You will find enclosed a copy of Service Bulletin S10RP regarding the batteries on certain 2009-2010 model year Blue Bird Vision model buses equipped with GM 8.1 propane engines.

Propane Vision Battery Drain

MODELS AFFECTED: 2009 & 2010 Propane Visions

S10RP

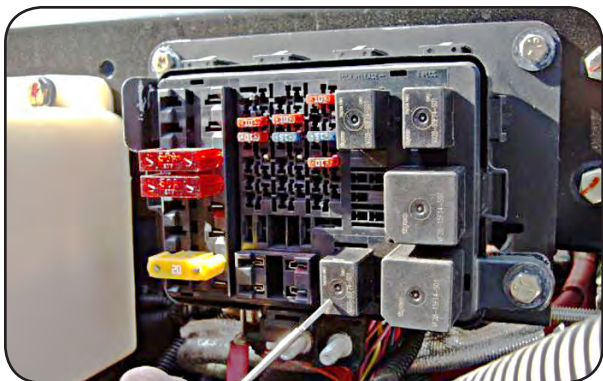
2 Rewire TAC Module Brake Relay, as follows:

2.1 Locate GM fuse block and remove cover.

2.2 Identify and remove TAC Module brake relay.

2.3 Remove the fasteners attaching the fuse block assembly to the crossmember. Tilt fuse block away from the crossmember to gain access to the wiring on back.

2.4 Locate circuit #1320 — a Blue 20 ga wire — connected to the TAC Module brake relay.

2.5 Remove circuit #1320 from its current location in fuse-block location E7 and insert it into location E8.

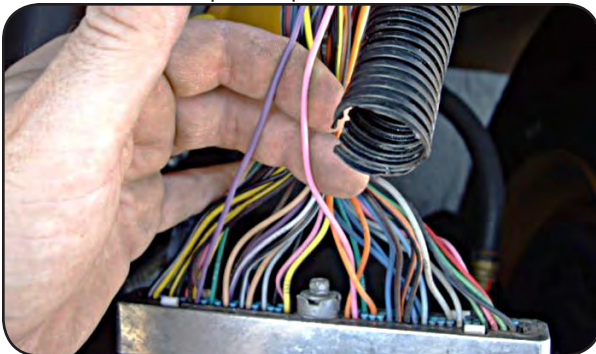
3 High Idle function wiring, as follows:

3.1 Locate the Powertrain Control Module.

3.2 Locate and disconnect the Blue 80 way connector.

3.3 Locate purple wire #420B in cavity #33 and pink wire #439A in cavity #19. Remove tape and loom from wiring harness to allow space to splice these two circuits.

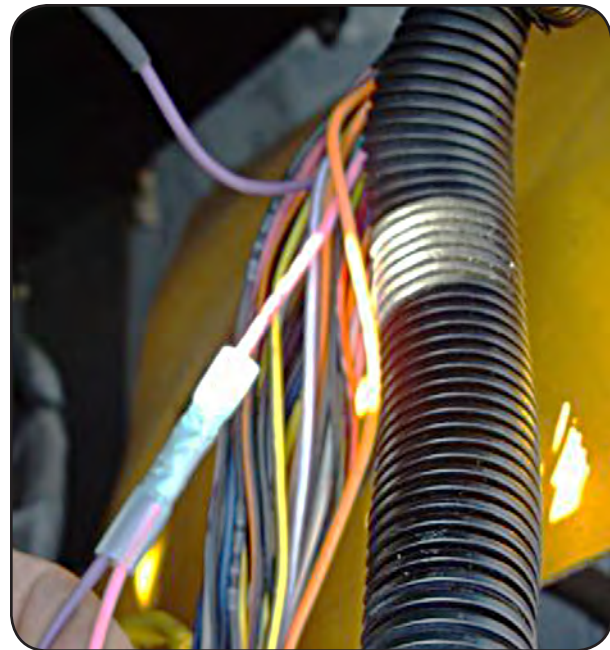
3.5 Fold back and tape to the harness the non-connector end of the purple #420B wire as it will no longer be used.

3.6 Strip ends and butt splice together the three remaining wires using a heat shrink butt connector.

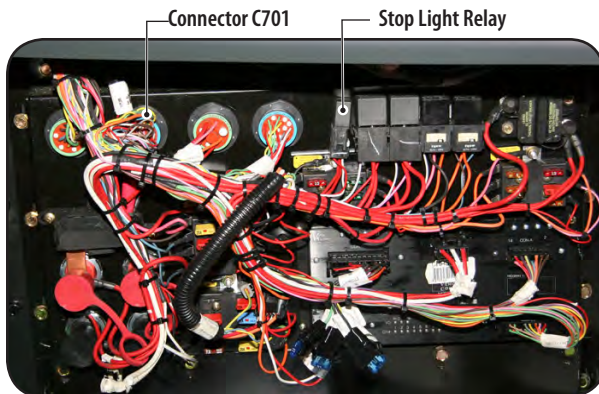
4.1 Remove PDU cover inside bus by removing the two thumb screws, one on each side.

4.2 Locate connector C701 on the left side of the PDU panel assembly and the stop light micro relay toward the top center of the PDU panel assembly .

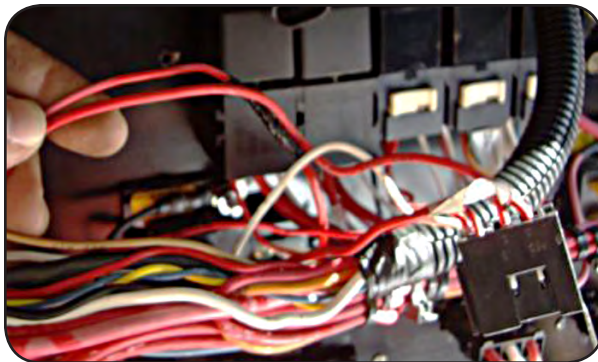
4.3 Cut cable ties securing wiring harness along the section between the stop light relay and connector C701.

4.4 Locate the Red wire labeled "CC Cancel" in cavity #24 of C701 and the Red wire labeled "Stop Light A" or "Stop Light B" connected to Pin #5 of the Stop Light Relay.

4.6 Fold back and tape to the harness the non -connector end of the red "CC Cancel" wire as it will no longer be used.

4.7 Strip ends and butt splice together the three remaining wires using a heat shrink butt connector.
